UNITED STATES PATENT AND TRADEMARK OFFICE

APPLICATION NO.	FILING DATE	FIRST NAMED INVENTOR	ATTORNEY DOCKET NO.	CONFIRMATION NO.
09/172,553	10/14/1998	JAMES E. GREEN	2914.IUS	9441

Office Action Summary

DETAILED ACTION

F I G . 4c

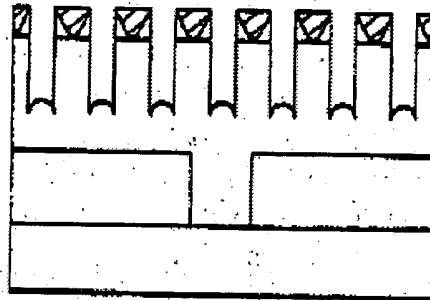
Regarding claims 31-32, 35 and 43, Jun et al. teaches an intermediate semiconductor capacitor structure (see figure 4c) comprising: a storage poly structure (13) comprising a plurality of contiguous mesas (consider the fingers or columns that include mask 15 and HSG 14 in fig 4c) with recess formed therein (consider the space between the fingers or columns in fig. 4c); a contiguous hemispherical-grain polysilicon (14) over said storage poly structure (13) (see fig. 4c) and a mask (15) over said hemispherical-grain polysilicon layer (14), said recesses (consider the space between the fingers or columns) being exposed through said contiguous hemispherical-grain polysilicon (14) and said mask (15) (see figure 4c).

With regards to the terms "contiguous mesas" or "contiguous webs", please refer to figures 4c and 6c, below. Please note that figure 4c shows shallow recesses that do not disturb the continuity of the storage poly structure 13. Thus, figure 4c shows storage poly fingers connected throughout in an unbroken sequence.

F I G . 6c

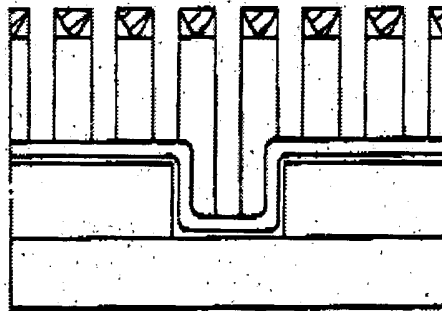
By the contrary, figure 6C shows deep recesses that disturb the continuity of the fingers. Thus, in this case figure 6c does not show contiguous fingers. Therefore, the terms "contiguous mesas" or "contiguous webs" in view of Jun et al. will be define according to figure 4c, in which shallow recesses are provided without disturbing the continuity of the storage poly.

**Fig. 22**

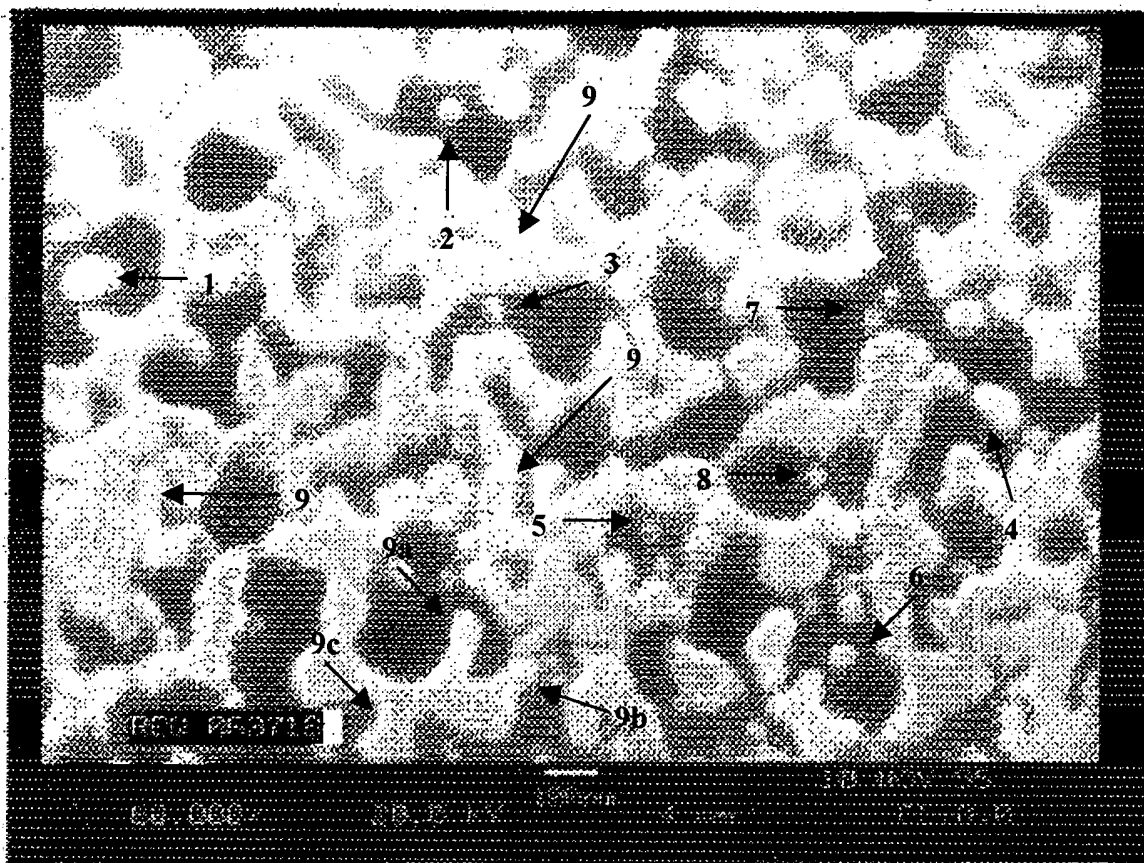
In addition, applicant also argues that Jun does not teach "a plurality of contiguous mesas" or "HSG having a web-like appearance." However, the examiner disagrees. On page 8 of Applicant's remarks, Applicant defined the terms "mesas" and "webs" as top surfaces of the storage poly. Based on such definition, Figure 22 (see below) shows, for example, top surfaces 1-9. It is noted that none of such "top surfaces" are contiguous as applicant argued. For instance, the "top surfaces" 1-8 are spaced apart from the main top surface 9.

A mesa or web defined as a mere portion or region of a top surface. For example, the mesas or webs (fingers 9a-9c in figure 22, above) are "contiguous" because they share the same top surface (9).

Fig. 9

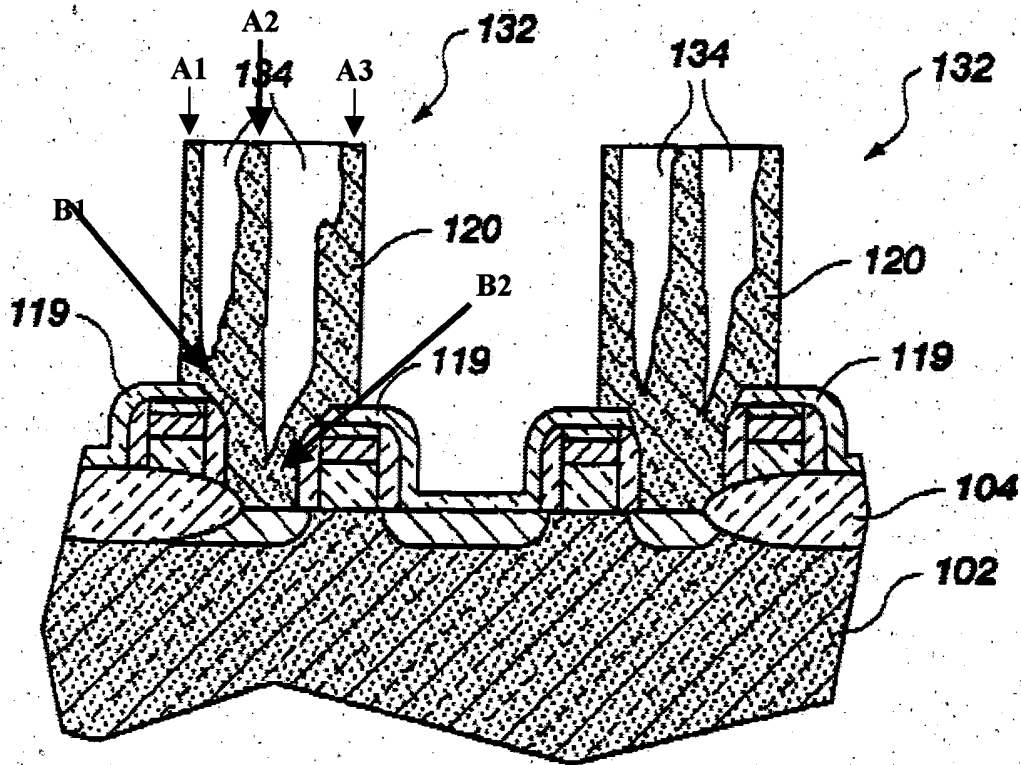
The mesas or webs are contiguous by sharing the same base. For example, top surfaces A1 and A2 share base (B1); and A2 and A3 share base (B2), which is adjacent to base (B1) (see fig 9, below).

Therefore, based on these interpretations it is believed that the reference Jun et al. anticipate the claimed invention. As such, the rejection under 35 U.S.C. 102(b) is considered to be proper.
